HISTORIC AND DESIGN REVIEW COMMISSION

October 16, 2019

HDRC CASE NO: 2019-581
ADDRESS: 134 CALLAGHAN AVE
113 LEIGH ST
LEGAL DESCRIPTION: NCB 719 BLK 1 LOT 8 OR RED 6
ZONING: RM-4, H
CITY COUNCIL DIST.: 1
DISTRICT: Lavaca Historic District
APPLICANT: Evan Morris
OWNER: Leslie Meenan
TYPE OF WORK: Fenestration modifications, roof replacement, site modifications
APPLICATION RECEIVED: September 27, 2019
60-DAY REVIEW: November 26, 2019
CASE MANAGER: Rachel Rettaliata
REQUEST:

Lavaca Remodel

FLOOR PLAN -
LEIGH ST

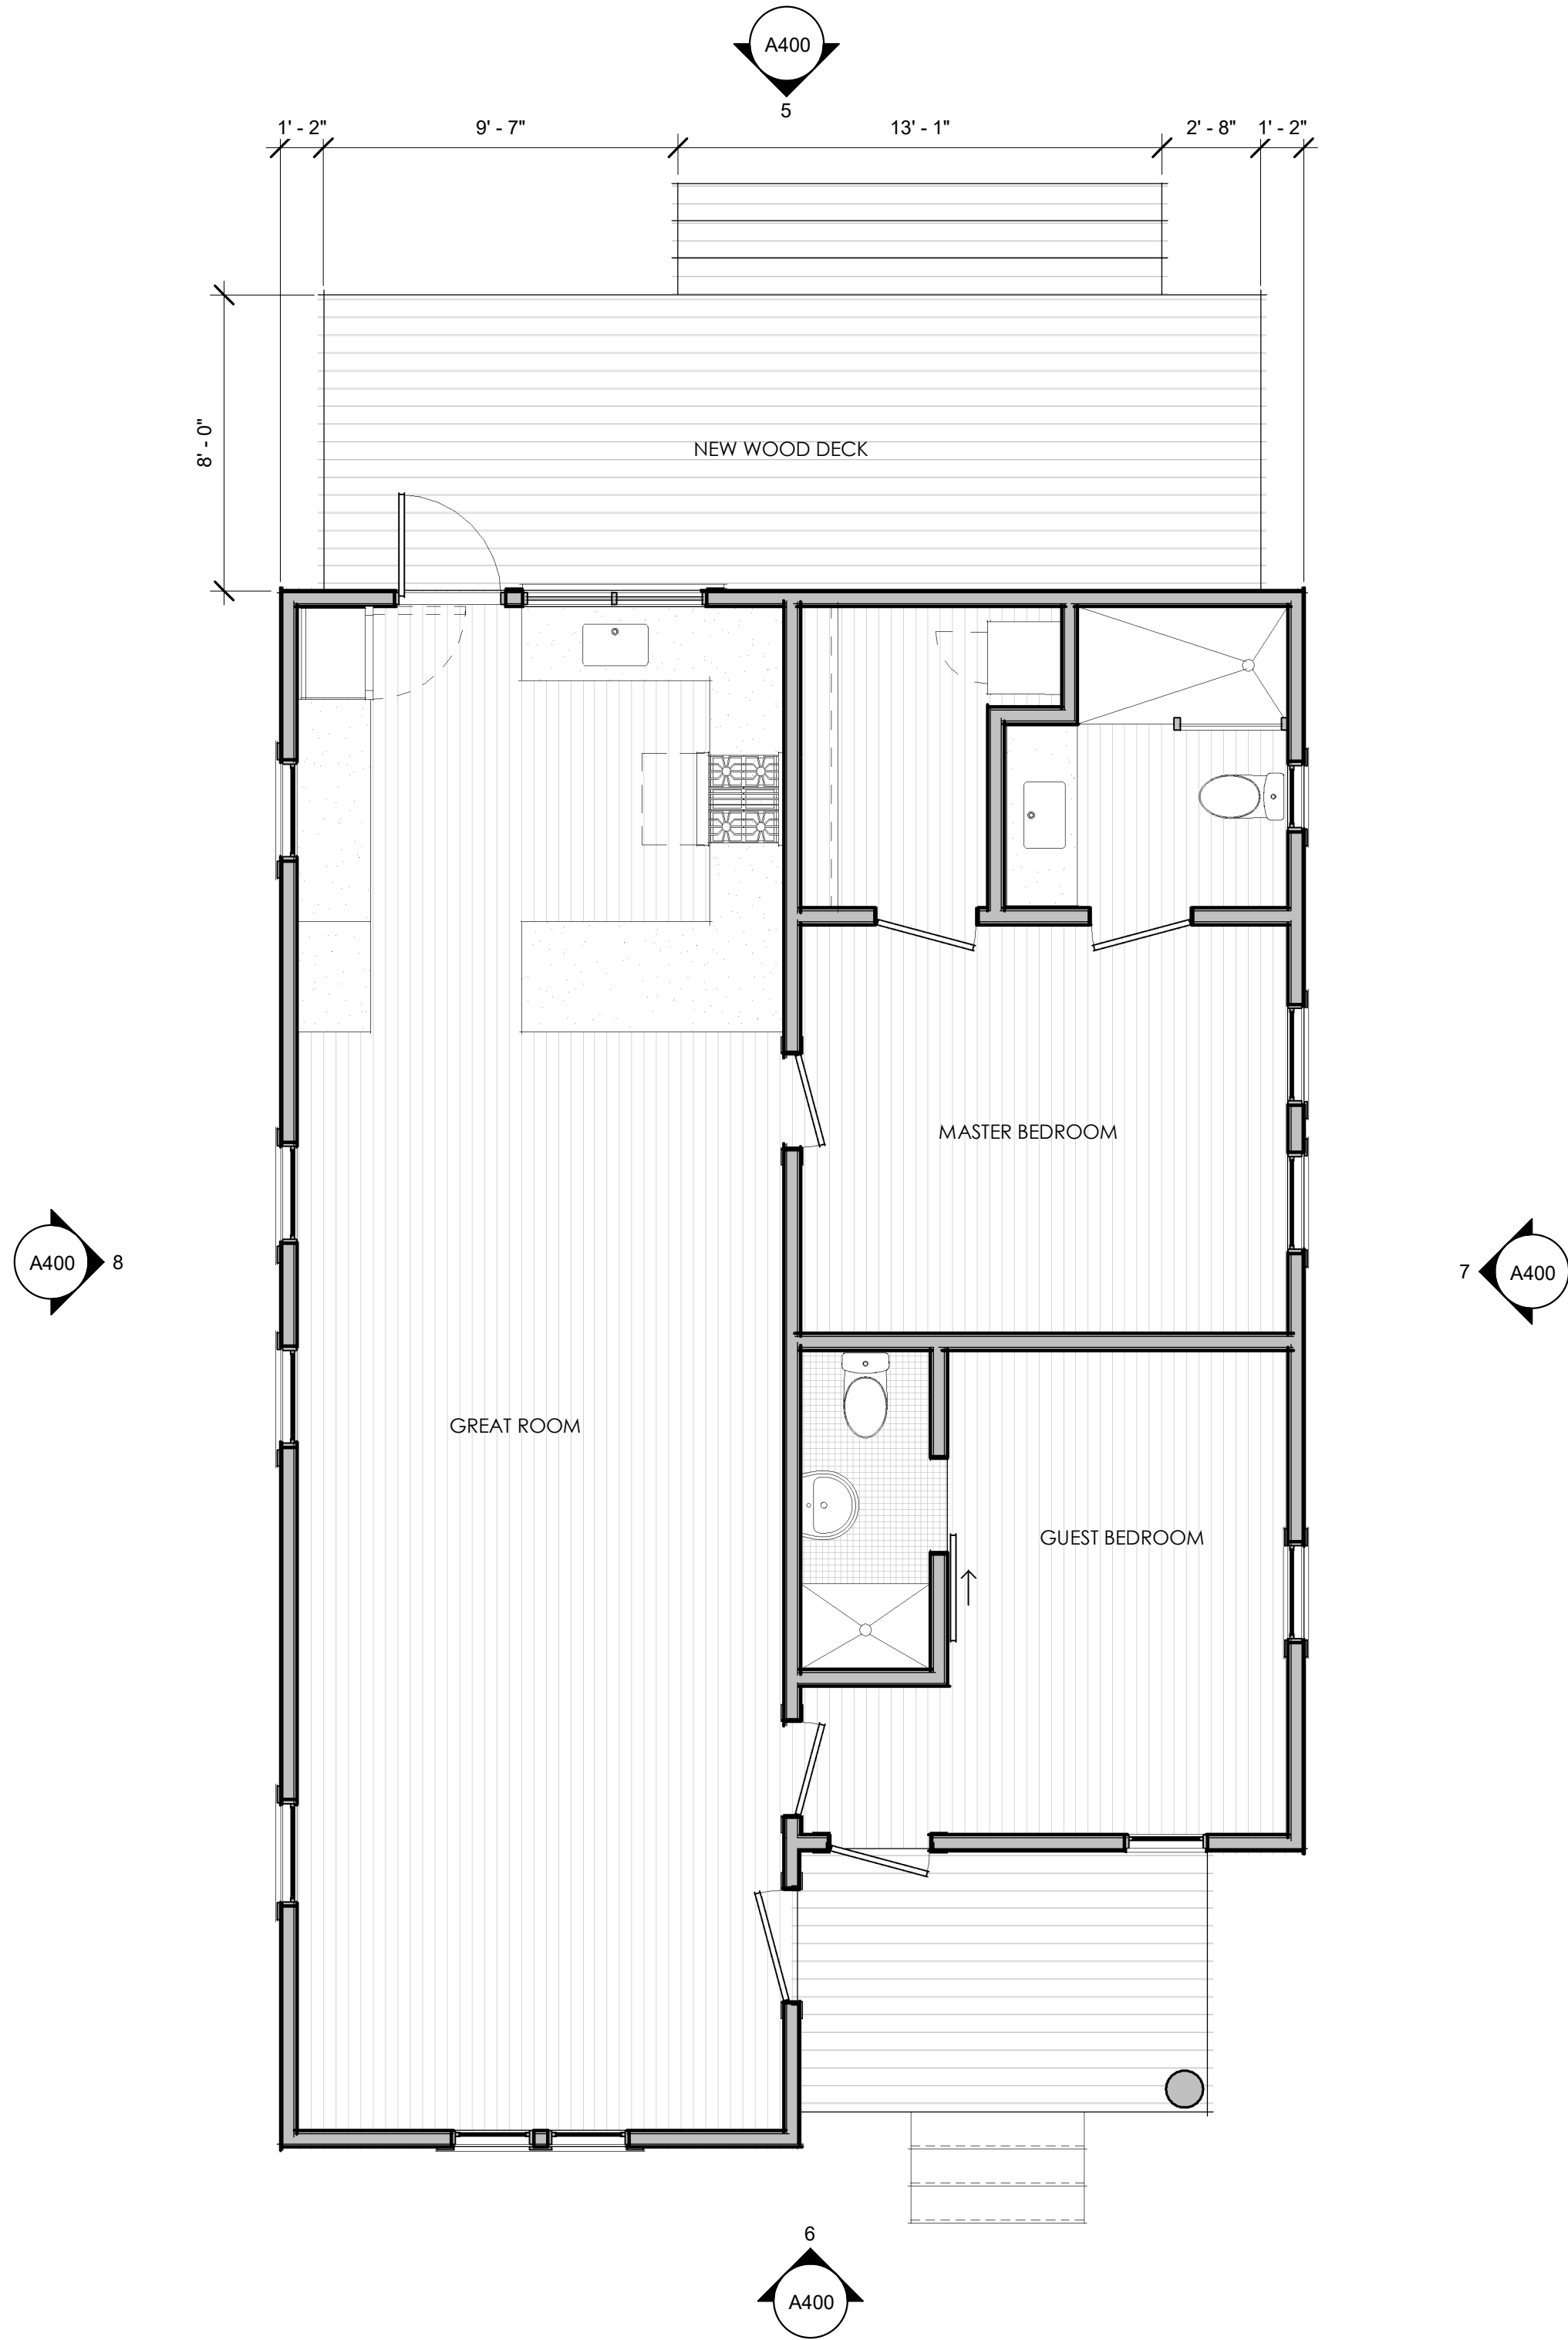
- 2d. FENESTRATION MODIFICATIONS AND WINDOW REPLACEMENT – The applicant has proposed to replace the existing fenestration on the side (west) elevation with Marvin Elevate series fiberglass-clad wood windows to match existing windows in size, operation, and divided lights. The applicant has proposed to reposition the windows and door on the rear (north) elevation and replace the windows and door with Marvin Elevate Series fiberglass-clad wood windows and door. According to the Guidelines for Exterior Maintenance and Alterations 6.A.iii., and 6.B.iv., in kind replacement of windows is only appropriate when the original windows are beyond repair. The Historic Design

Guidelines also state that replacement windows and new windows should match the historic windows in terms of size, type, configuration, material, form, appearance, and detail when original windows are deteriorated beyond repair. The Historic Design Guidelines for Doors state that existing door openings should be preserved and creating new primary entrances on the primary façade or where visible from the public-right-of-way should be avoided. Additionally, the Guidelines state that doors should be replaced in-kind when possible and when deteriorated beyond repair. New entrances, when necessary to comply with other regulations, should be compatible in size, scale, shape, proportion, material, and massing with historic entrances. Staff finds that the applicant has not provided evidence that the original windows and doors are deteriorated beyond repair and the proposal is not consistent with the Guidelines.

Item 2b, Staff does not recommend approval of the window replacement based on finding 2d. Staff recommends that the applicant repair the existing wood windows in place.

- i. That the applicant installs one-over-one fully wood windows to match the existing configuration as closely as possible. The proposed aluminum clad replacement product is not appropriate. Meeting rails must be no taller than 1.25" and stiles no wider than 2.25". There should be a minimum of two inches in depth between the front face of the window trim and the front face of the top window sash. This must be accomplished by recessing the window sufficiently within the opening or with the installation of additional window trim to add thickness. The final specification should be submitted to staff for review prior to the issuance of a Certificate of Appropriateness.

Item 2c, Staff recommends approval of the fenestration modifications based on finding 2d with the following stipulations:

- i. That the applicant repairs all original wood windows in place and that all new windows installed are fully wood windows and doors without cladding. New fenestration must be in keeping with historic size, type, configuration, material, form, appearance, and detail. The applicant is required to submit a final window specification for wood windows and doors to staff for review and approval. The windows must meet the following stipulations: meeting rails must be no taller than 1.25" and stiles no wider than 2.25". There should be a minimum of two inches in depth between the front face of the window trim and the front face of the top window sash. This must be accomplished by recessing the window sufficiently within the opening or with the installation of additional window trim to add thickness. Window trim must feature traditional dimensions and architecturally appropriate sill detail. Window track components must be painted to match the window trim or concealed by a wood window screen set within the opening.

- ii. That the applicant submits updated elevations to staff for review and approval prior to receiving a Certificate of Appropriateness.
